Front/West Wall

Elevations with window numbers, interior photos and close-up exterior photos provided by applicant. Windows in yellow indicate applicant will retain them.

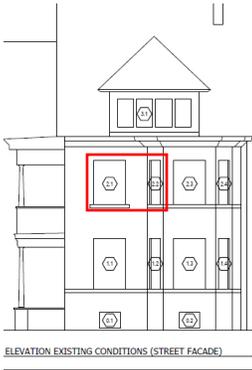
The above image shows an a/c unit installed, which was in place a minimum of six years. But due to time gaps in Google photos, it could have been in place longer. The exposure to the elements from the open window and a/c unit may be the main factor why this window sash is significantly more deteriorated than the other two bay window units.

It is staff's opinion this window may be deteriorated to the level of replacement. However, a new wood double-hung window, matching the sash dimensions and profile (and all other details) should be fabricated. This window opening is one part of the two-story bay window; a standard replacement window within this composition would stand out too strongly and would alter this distinguished character-defining feature on the façade.

1.8

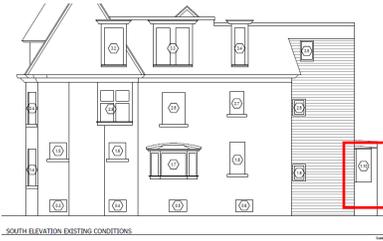
Window 1.8 – Different design that the remaining windows at the first and second floor, the 2-over-2 double-hung (which at first appears to be 4-over-4 due to the interior moveable bottom storm window that is partially open) is also found in the same location on the north wall, as well as one window on the east wall.

This window pattern was popular from the mid-1850s to the beginning of the 20th century. It is possible, but can't be proven, that this window sash was from the original (pre-1897) dwelling and wasn't replaced in the 1913 remodeling.

Regardless, it is a window of historic age, and not a total outlier as there are two other identical windows in similar locations. The window is intact and appears to be in repairable condition.

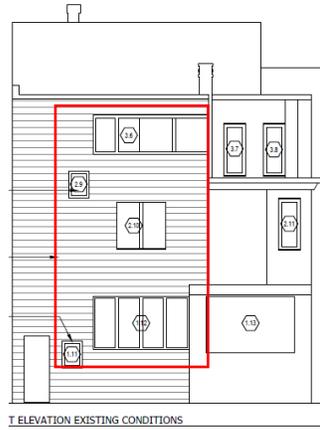
Windows 3.2, 3.3 and 3.4
Existing windows are contemporary replacement units. Installation of new aluminum-clad wood windows is compatible within the parameters of the Standards.

1.13

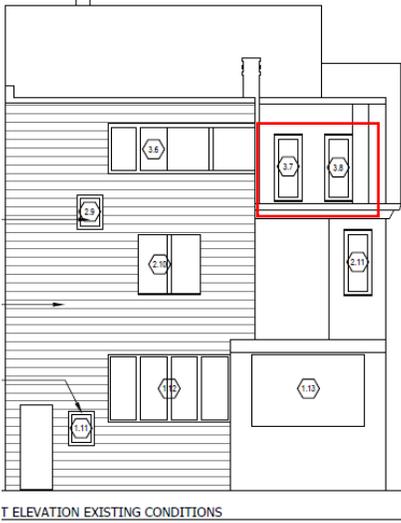
Window opening 1.13
 The existing openings do not contain historic window sash the opening has been heavily altered.
 The proposal, as shown in the “after” elevation (at left), will return a uniformity to this elevation.

3.7

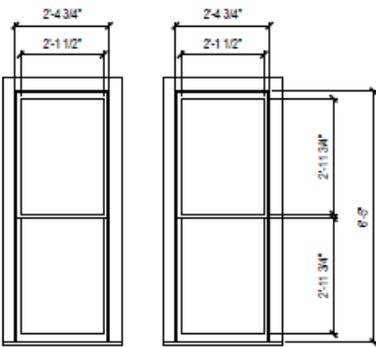
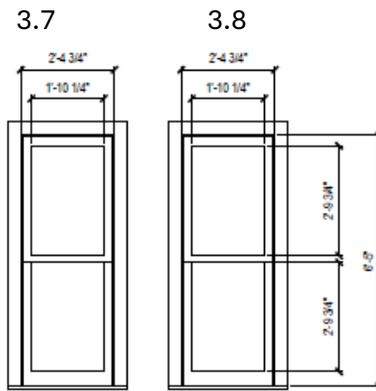
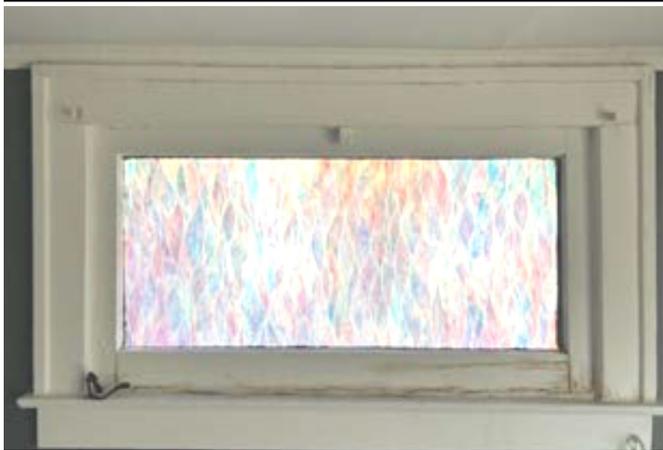
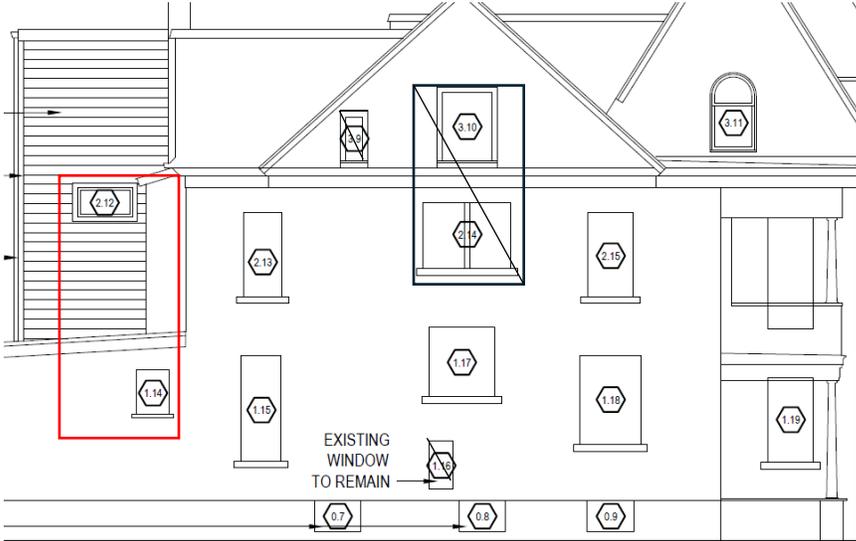
Similar to the façade window 1.4, window 3.7 suffers from additional deterioration due to long term exposure caused by a window a/c unit (although additional photos could help the assessment). The adjacent window, 3.8, appears to be in repairable condition.

However, as the windows are adjacent each other, it's staff's opinion they should be considered with the same action-repair or replacement. As these openings are on the rear elevation and recessed behind the three-story addition; they are not publicly visible.

The dimensions of the proposed windows are close to the historic units. And at the recessed second floor location, staff doesn't believe the replacement units will be noticeable, won't alter the historic features of the property and believes the replacement meets the National Park Service guidelines document [Replacement Windows that meet the Standards](#).

2.12

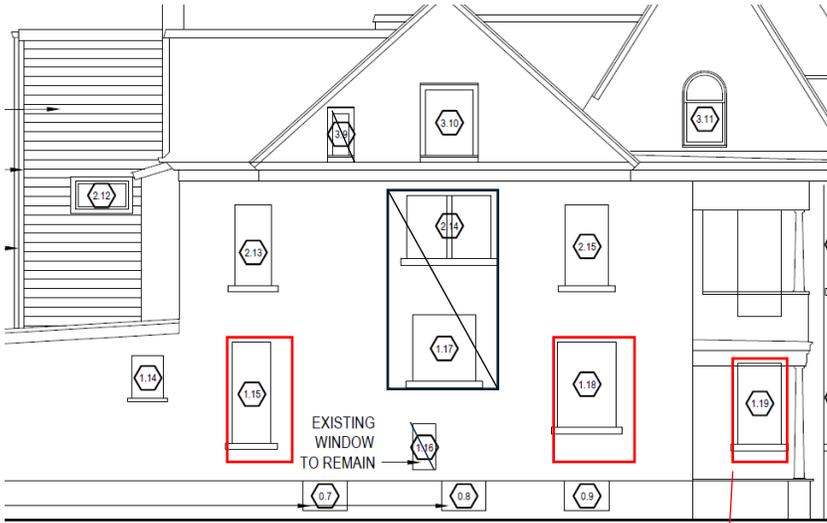
Applicant requests to replace 2.12 (on north wall of enclosed rear three-story porch).

Applicant requests to replace 1.14.

These windows are not visible from any public view. Both windows appear to be repairable, therefore, staff determines that the replacement proposal doesn't meet Secretary of the Interior Standard 6.

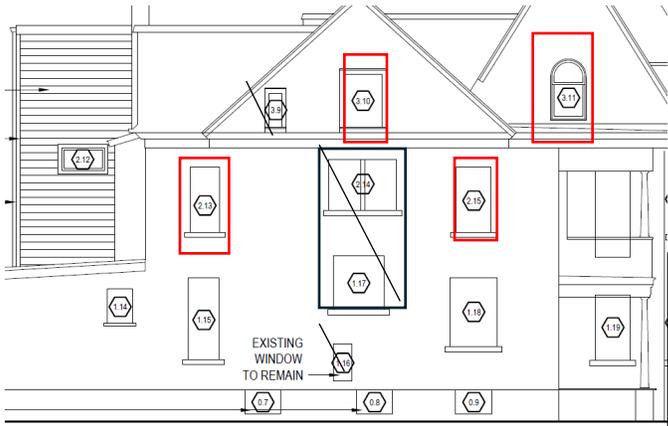
The applicant requests to replace remaining north elevation windows (shown on this and following pages).

It is staff's opinion that they all appear to be in good condition (likely due to their limited exposure) and can be repaired.

Should the Commission take visual appearance into consideration, it should be noted that the only window on this page that is in public view is the window at 1.19; it is located on the front porch and adjacent the front entrance.
